City of Phoenix
PLANNING & DEVELOPMENT DEPARTMENT

Staff Report: Z-SP-12-17-8
December 20, 2017

Request To: C-2 SP SPVTABDO (Intermediate Commercial District with a Special Permit, South Phoenix Village and Target Area B Design Overlay District) (0.80 acres)

Proposed Use: Automobile retail sales and all underlying C-2 uses

5. Elevations

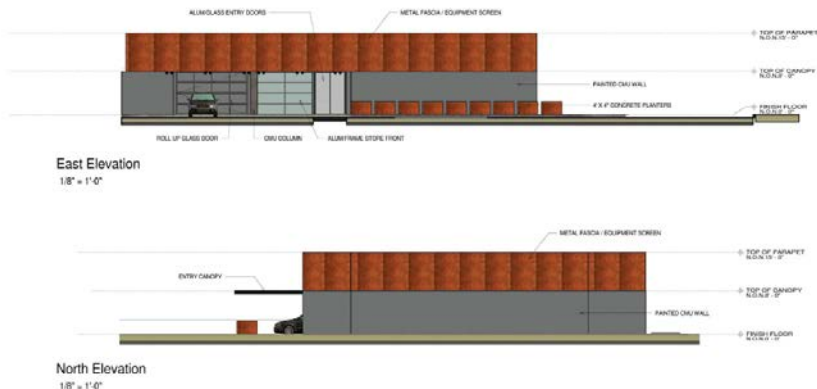
The elevation plans depict exterior improvements to the building such as a roll up glass door, a metal fascia equipment screen around the face of the building, and four-foot by four-foot concrete planters along the front of the building.

RD.1

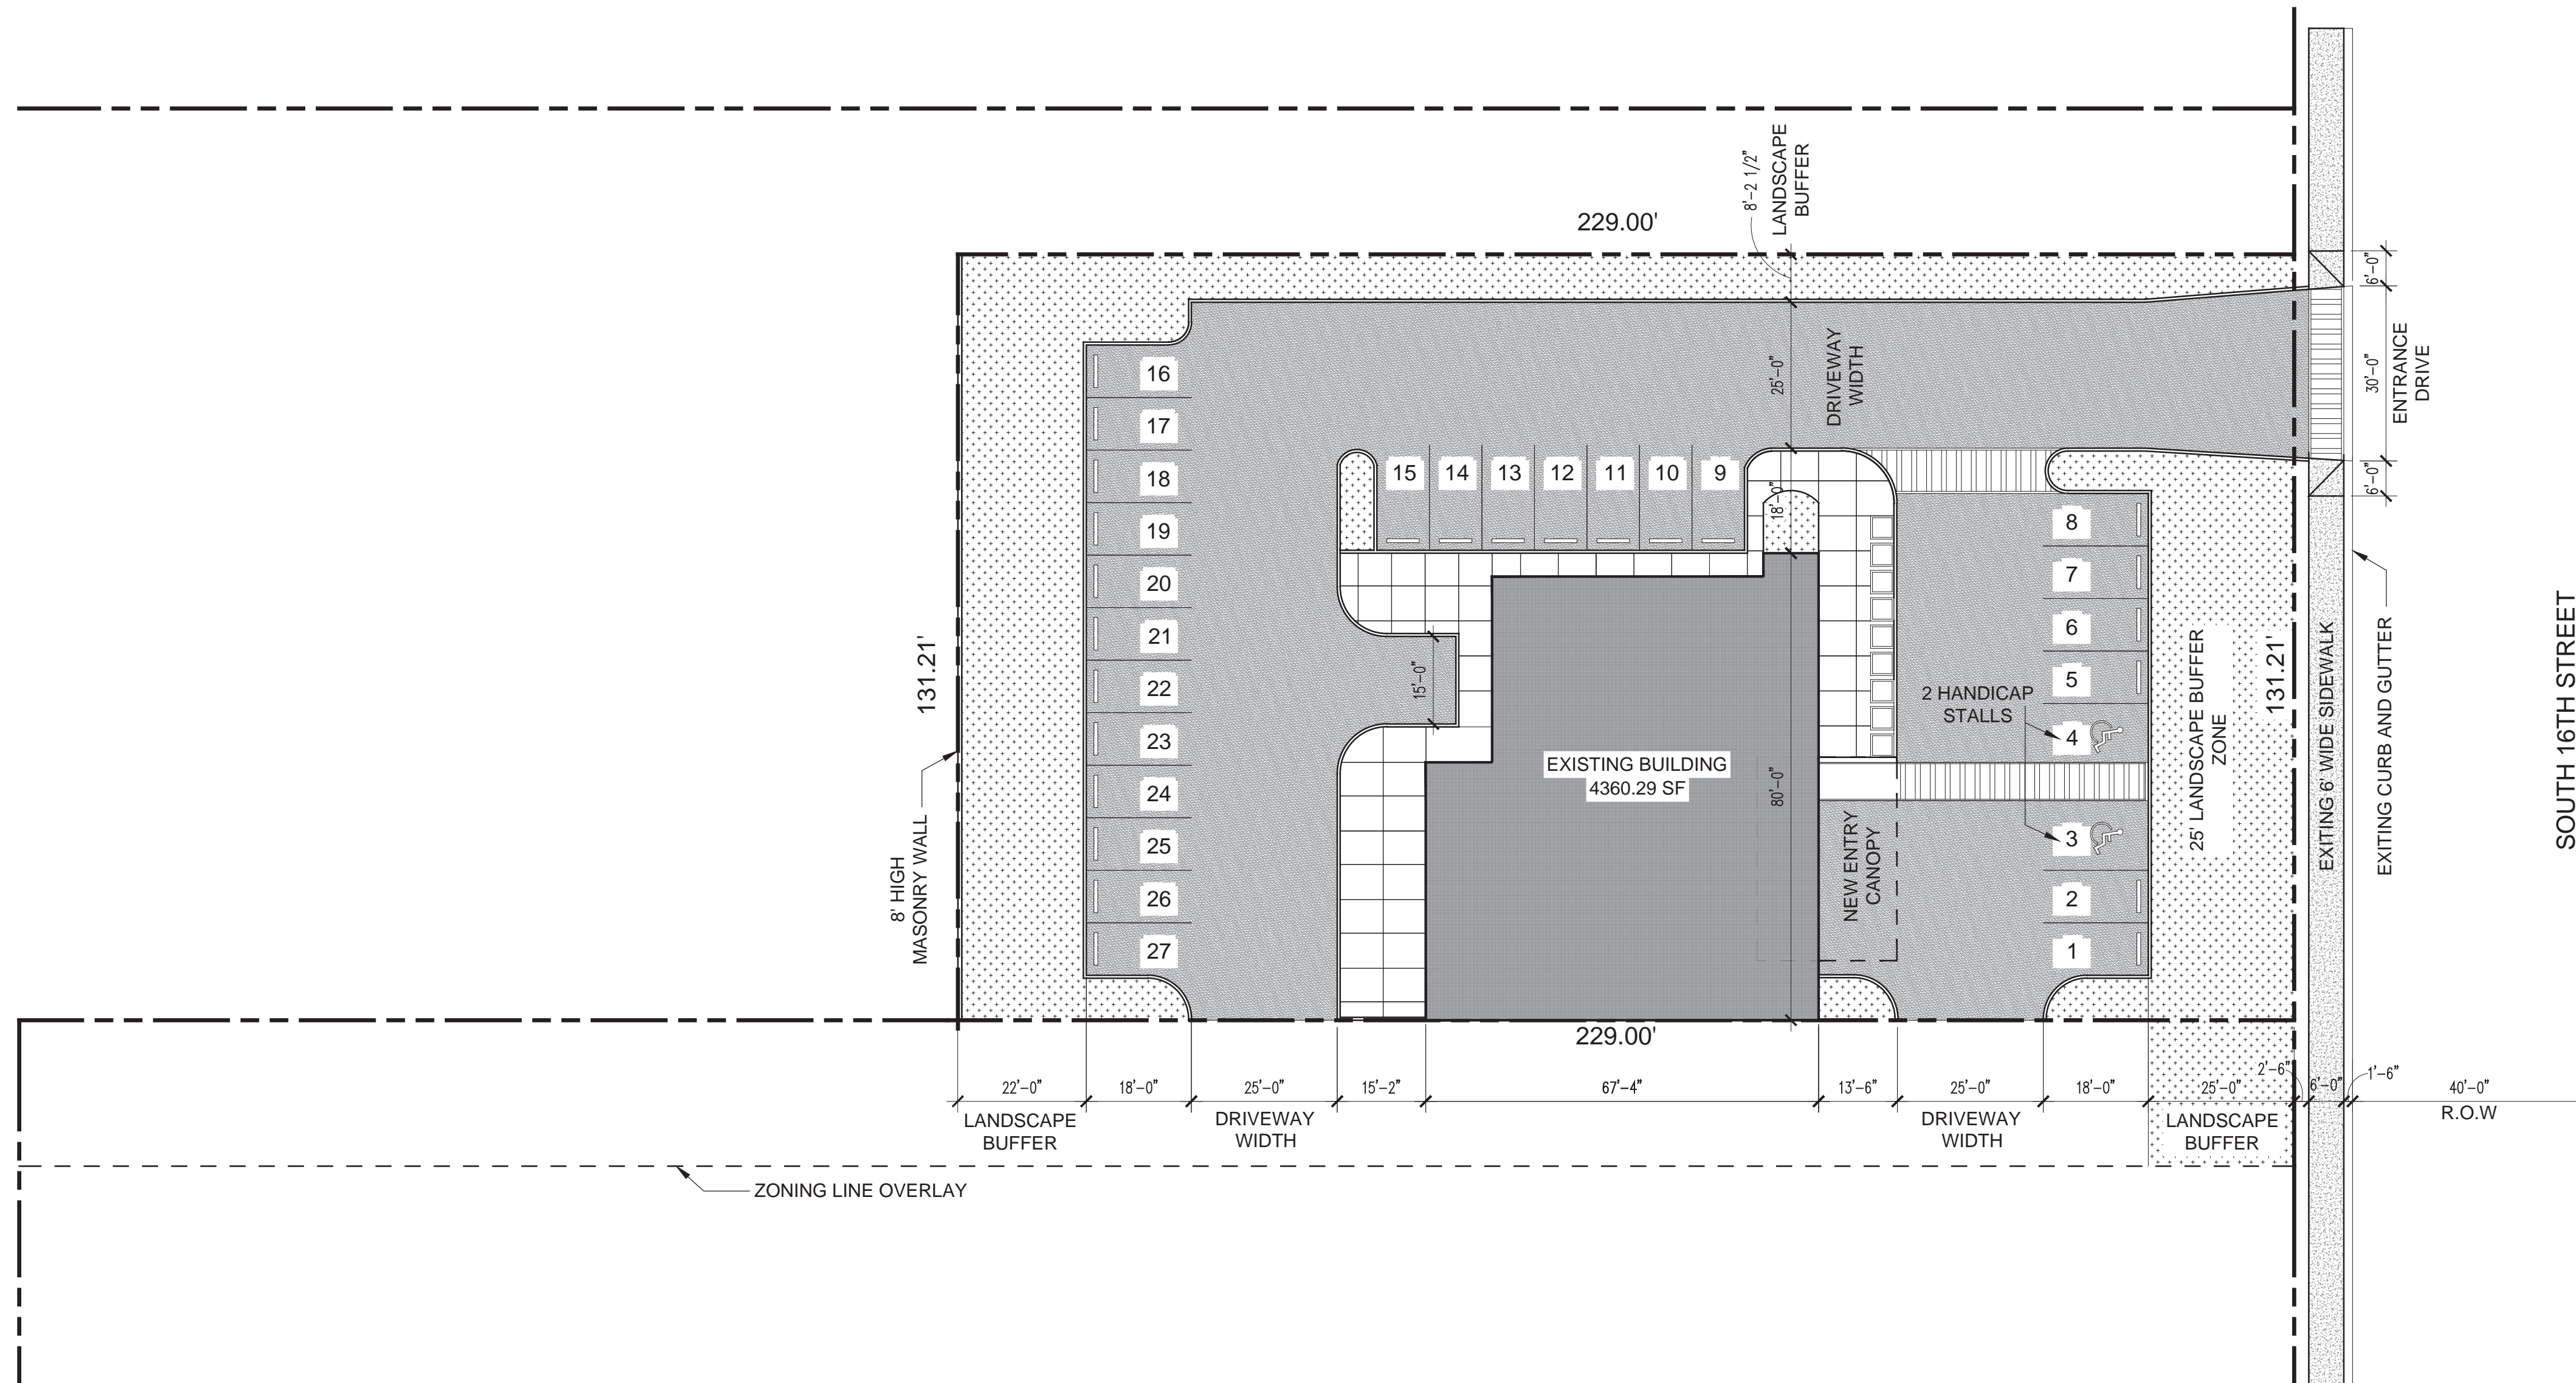
There will be no major changes to the overall footprint of the building; however, some interior and exterior improvements will occur, such as improvements to the landscaping, a new entrance driveway along 16th Street, an

expansion of parking lot paving, and newly painted parking spaces. The building will be improved and used as an automobile sales office on the subject site. The vehicles for sale will be displayed and repaired on the property to the south. The site plan notes two driveways connecting both parcels which will allow them to function together as one site when necessary.

The site has a chain link fence topped with barbed wire along the southern boundary of the site. The City of Phoenix Zoning Ordinance, Chapter 7, Section 703, prohibits the use of chain link fencing on a non-residential development where visible from a public street or residential zoning districts. In addition, the Zoning Ordinance prohibits the use of fences topped with barbed wire when visible from a public street or residential zoning districts. Subsequently, the existing chain link fence and barbed wire must be removed or relocated to not be visible from the public rights-of-way or residential zoning districts. Should the two driveways connecting the two parcels be gated, a wrought-iron gate would be required. This requirement is addressed in Stipulation No. 1.

12. The Street Transportation Department has indicated that the developer shall provide a 10-foot sidewalk easement for the west half of 16th Street and that the developer shall provide a 30' P1255-1 driveway on 16th Street. Further, Street Transportation has indicated that the developer shall construct all streets within and adjacent to the development with paving, curb, gutter, sidewalk, curb ramps, driveways, streetlights, median islands, landscaping and other incidentals as per plans approved by the City. All improvements shall comply with all ADA accessibility standards. This is

1. If a gate or gates are utilized for drive aisles between the C-2 SP and A-2 portions of the site, the gate(s) shall be wrought iron, as approved by the Planning and Development Department.

3. The developer shall provide a 10-foot sidewalk easement for the west half of 16th Street, as approved by the Planning and Development Department.
4. The developer shall provide a 30-foot P1255-1 driveway on 16th Street, as approved by the Planning and Development Department.
